Interactive comment on “Investigation of a low-cost magneto-inductive magnetometer for space science applications” by Leonardo H. Regoli et al.

Received and published: 5 January 2018

Fig. 1.

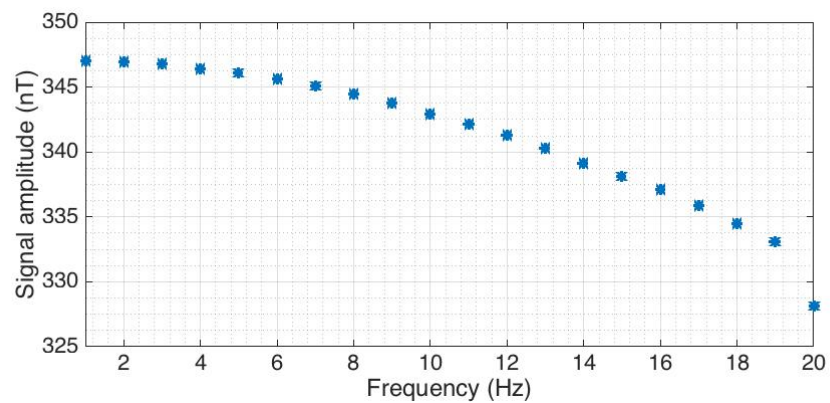
4. The amplitude of the signal is not included in the paper because at the current stage we are not able to distinguish between the attenuation caused by the sensor itself and that caused by the change in the impedance of the coil used to generate the field with frequency. I am attaching the plot for reference, but we feel that including it in the paper would lead to confusion, hence we decided to just include the SNR.
